SUPPLEMENTAL MEMO

SUBJECT: PDC05-122. PLANNED DEVELOPMENT REZONING PERMIT TO ALLOW THE REZONING OF A PROPERTY FROM THE R-M MULTI-FAMILY RESIDENCE ZONING DISTRICT TO THE A(PD) PLANNED DEVELOPMENT ZONING DISTRICT TO ALLOW ONE SINGLE FAMILY DETACHED RESIDENCE AND UP TO 13 SINGLE-FAMILY ATTACHED RESIDENCES ON A 0.71 GROSS ACRE SITE LOCATED ON THE EAST SIDE OF RADIO AVENUE, APPROXIMATELY 160 FEET NORTH OF LINCOLN COURT, (2102 RADIO AVENUE) (WILLOW VILLAGE SQUARE, LLC PAUL MAJOULET, OWNER).

PLANNED DEVELOPMENT ZONING
Willow Village Square
2102 Radio Avenue San Jose, CA.

PDC05-122
DEVELOPMENT STANDARDS
(As revised 8/20/07 per the Planning Commission's recommendation and per the applicant's revised plans)

SITE PLAN 1" = 20'-0"

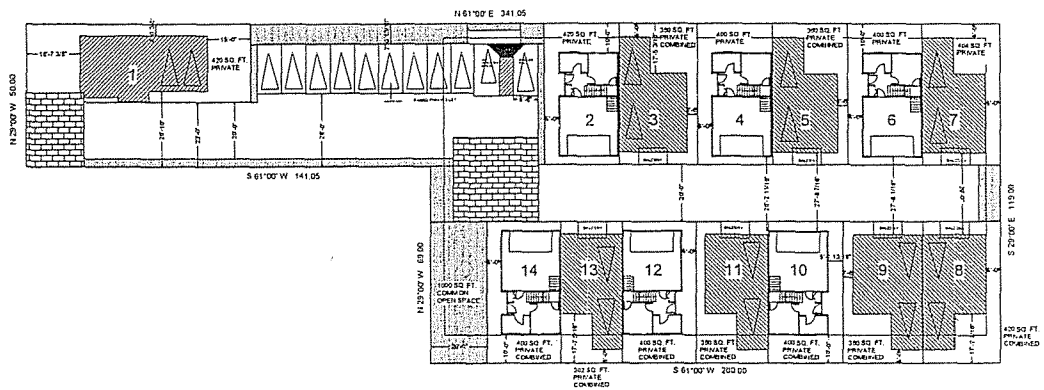
On August 20th, the applicant presented a revised site plan to staff to demonstrate that it is possible to comply with the Planning Commission's recommendation that 50% (seven) of the units have two-car, side-by-side garages. The applicant's revised site plan also shows that nine of the units would have increased private open space of at least 400 square feet of private open space, four units will have at least 320 square feet of private open space (60 square feet as private balconies) and one unit (#13)

will have 302 square feet of private open space. Three of the revised units that have side-by-side garages show a minimum 10-foot setback, and four of the units with one-story tandem garages retain a minimum 5-foot setback from southern property line adjacent to single family residential. This conceptual site plan has been revised to include 1,000 square feet of common open space area.

As a result of these revisions, there is a decrease of one open parking space on site. The parking requirement for this project is based on proposed bedroom count and the type of parking provided. As revised, the project provides parking for half the units in side-by-side, two-car garages. Based on the Residential Design Guidelines standards, 38 parking spaces are required for the revised proposal, and 39 parking spaces are provided.
